**ADDENDUM #2**

**MSAD #72  
PRE-K-8 SCHOOL AT MOLLY OCKETT  
FRYEBURG, MAINE**

**APRIL 29, 2015**

**Existing Gazebo at  
Molly Ockett School, Fryeburg, Maine**

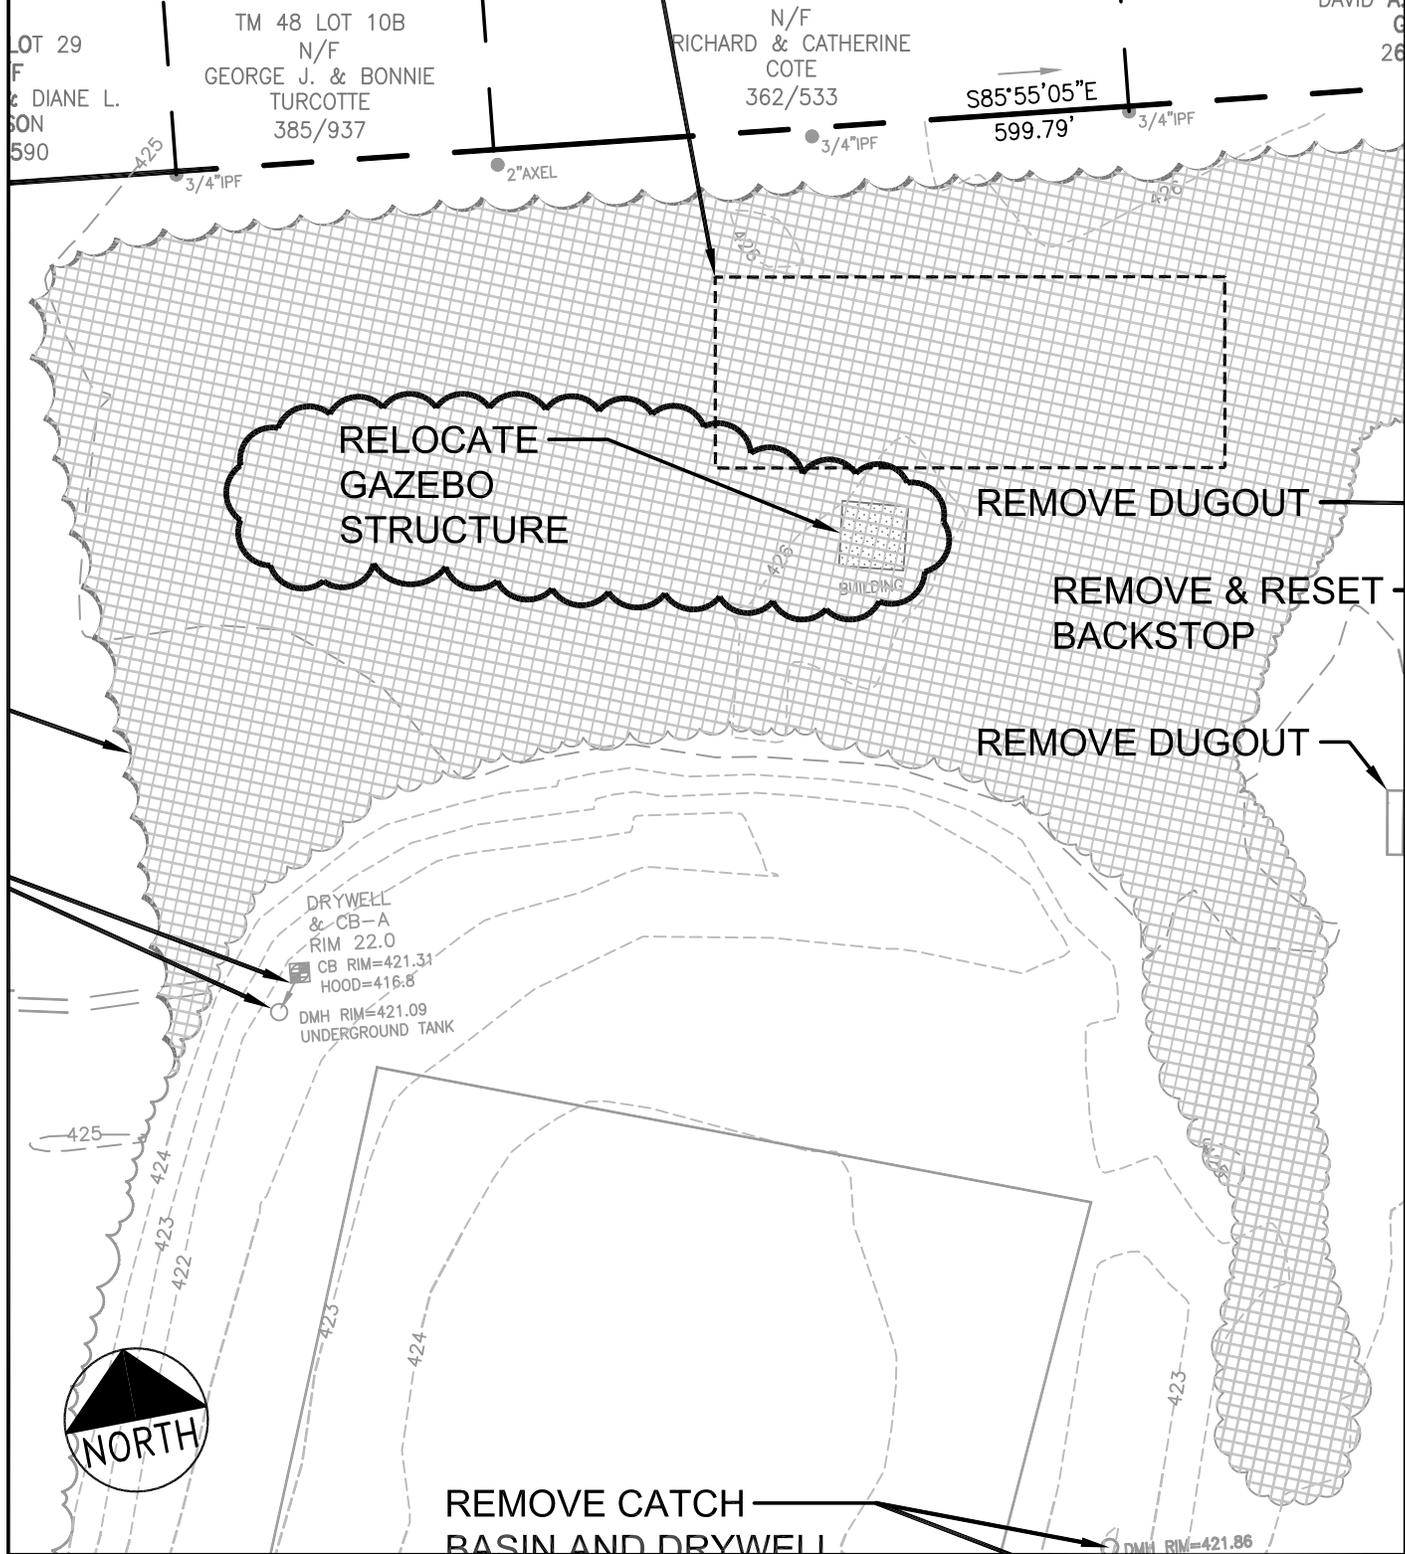
- A. Bid Alternate No. 5 shall be revised to include removing and relocating the existing playground equipment as well as the existing gazebo at the Molly Ockett School. The gazebo shall be relocated on the easterly side of the vehicle maintenance garage. A 12" thick structural fill pad shall be placed in the area of the relocated gazebo with 12" diameter concrete fill sonotube pier foundations extending 5' below finish grade for each gazebo support post. Photos of the existing gazebo are appended to this addendum.

FIGURE  
**CSK-4**

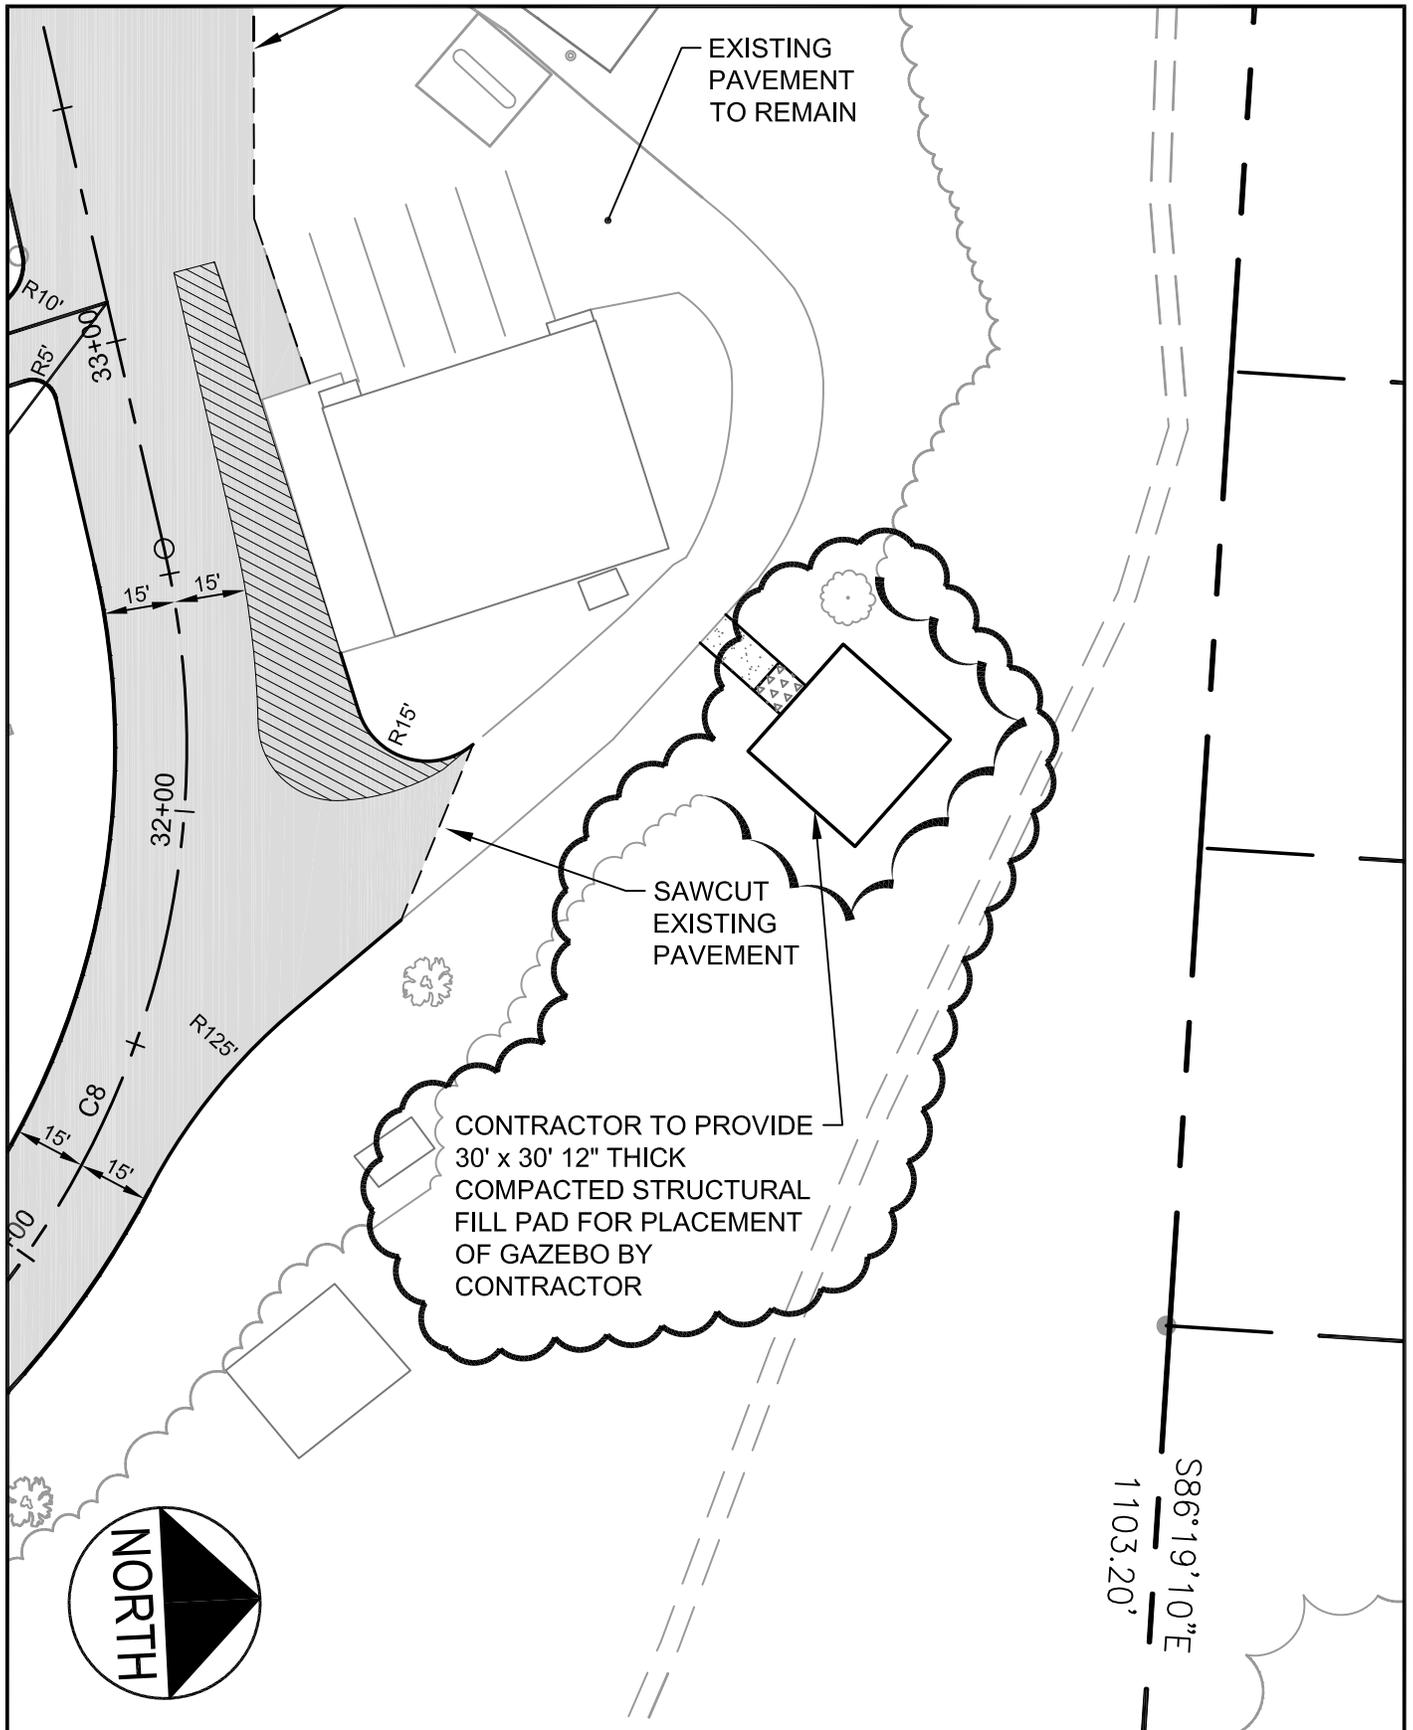
A. The removal of the existing gazebo by others shall be changed to “relocated by contractor”. This revision to Sheet C-1.2 is shown on CSK-4 that is appended to this addendum.

**EXCERPT OF SHEET C-1.2  
 REVISED NOTE TO RELOCATE GAZEBO  
 STRUCTURE IN LIEU OF REMOVAL**

FIGURE  
**CSK-5**

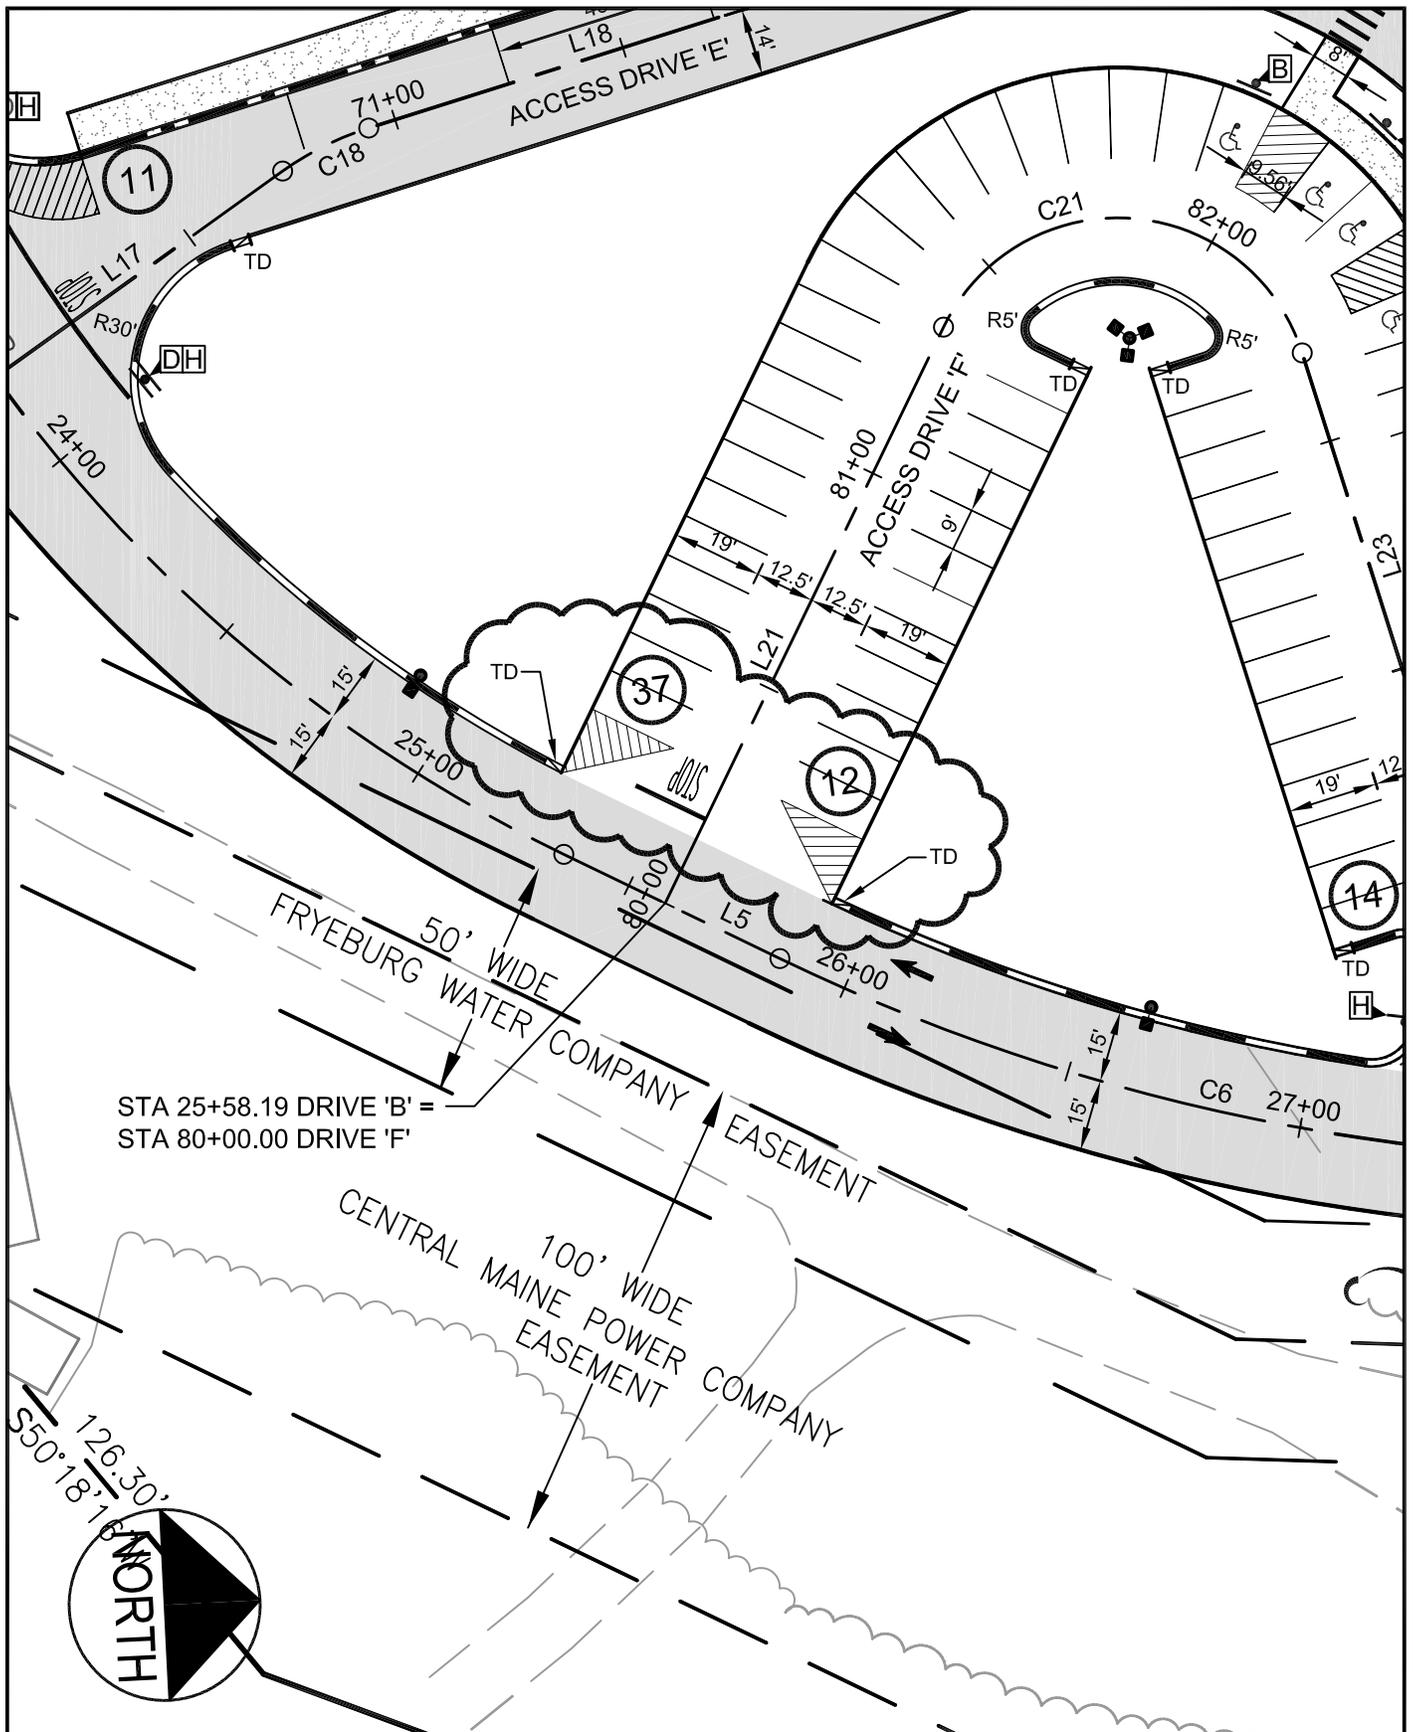
A. The existing gazebo is to be relocated to the easterly side of the vehicle maintenance garage. The contractor is required to clear vegetation, prepare subgrade and place a 30’ by 30’ structural fill pad (12” thick) prior to resetting the existing gazebo in this location. This revision to Sheet C-2.2 is shown on CSK-5 that is appended to this addendum.

EXCERPT OF SHEET C-2.2  
REVISED NOTE TO INDICATE  
NEW GAZEBO LOCATION

DRAWN: CDD	DATE: 04.28.15	FIGURE <b>CSK-6</b>
DESIGNED: JAL	SCALE: 1" = 40'	
CHECKED: JAL	JOB NO. SF-M044A	
FILE NAME: SF-M044A-SITE

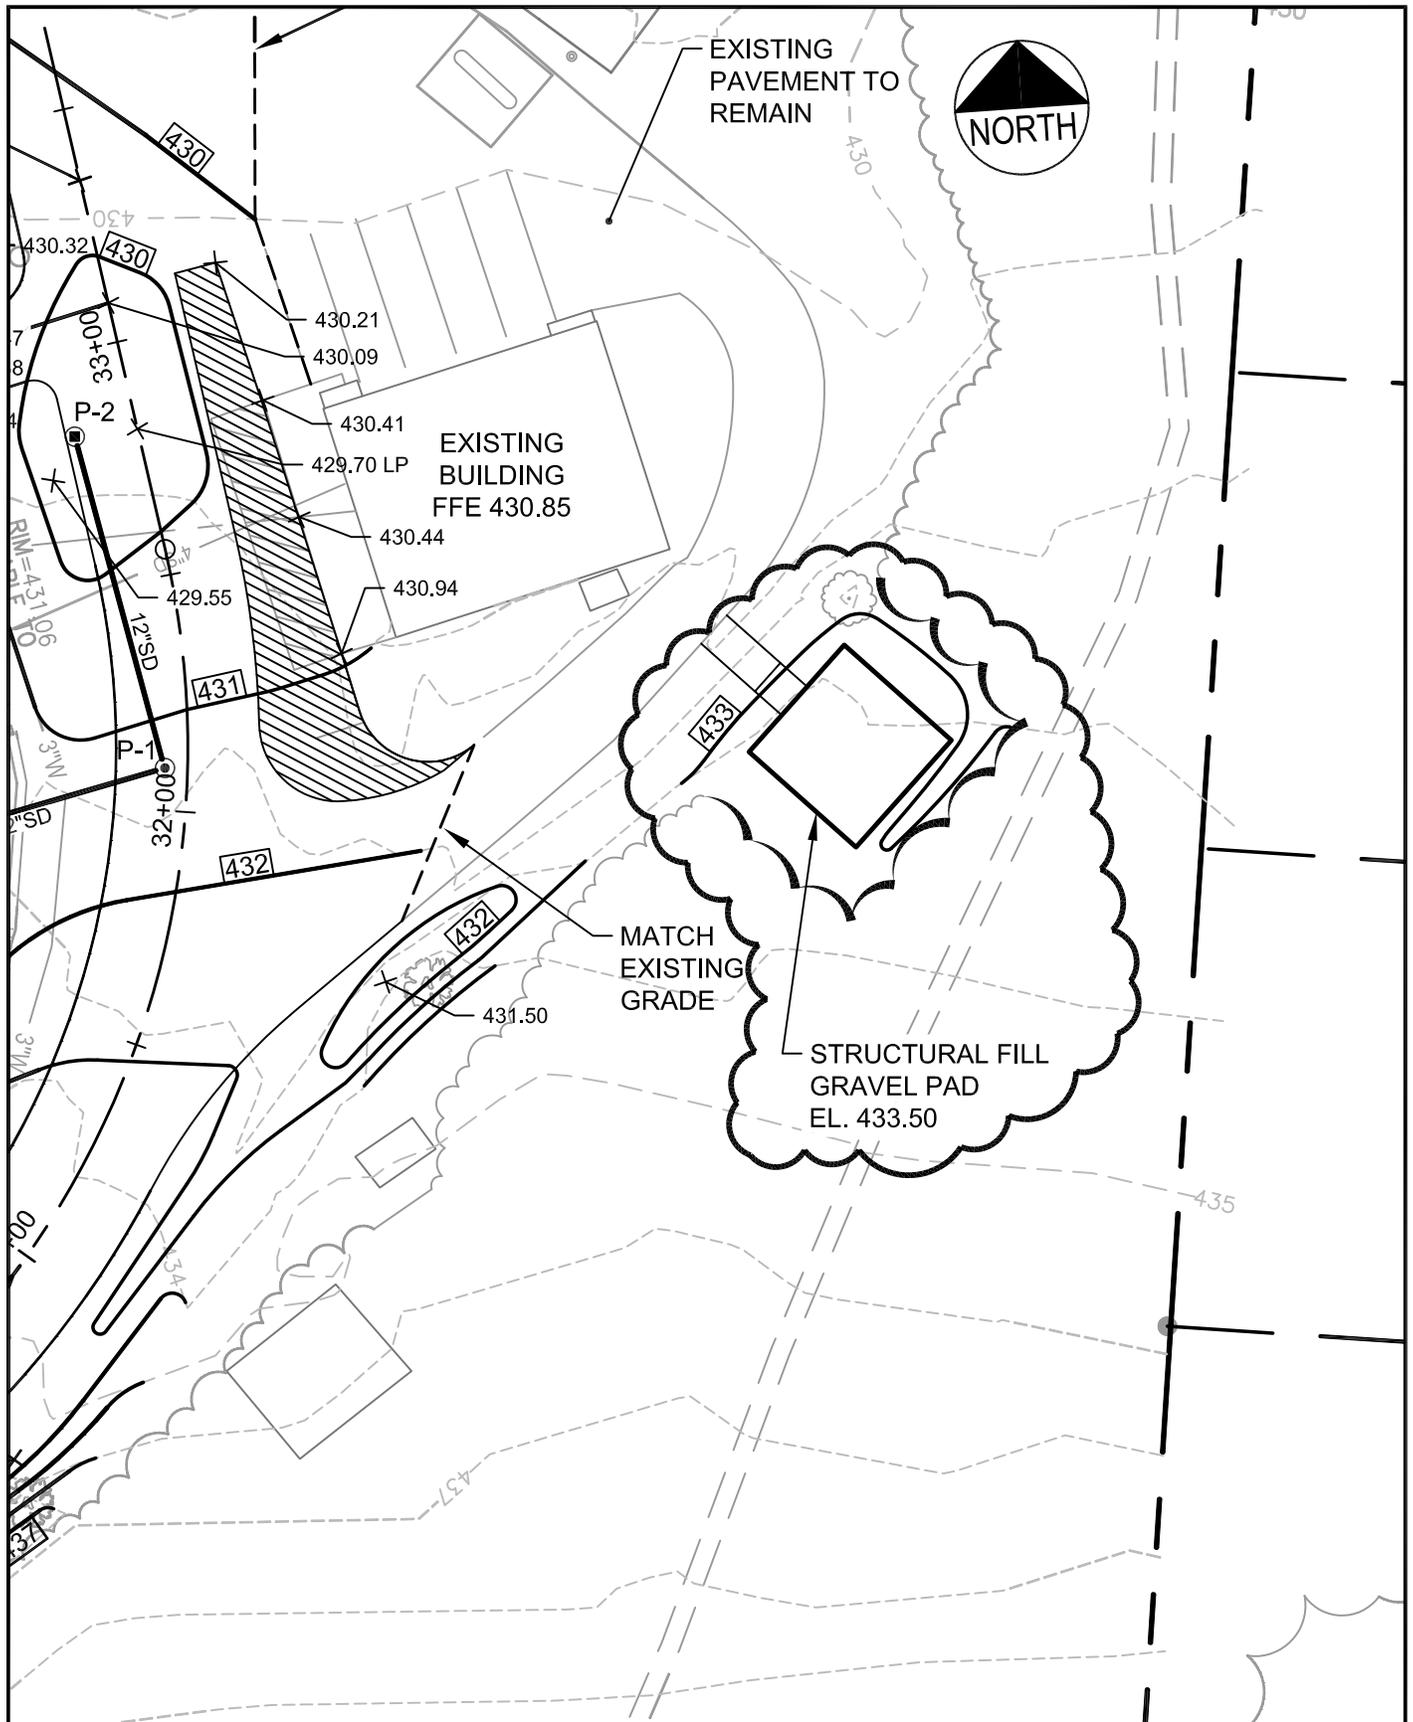
B. The raised landscape islands have been eliminated at the southeasterly end of the 63 space staff parking lot. The extent of standard duty pavement has been expanded. This revision to Sheet C-2.2 is shown on CSK-6 that is appended to this addendum.

EXCERPT OF SHEET C-2.2  
REVISED CURB / STRIPING  
AT ACCESS DRIVE 'F'
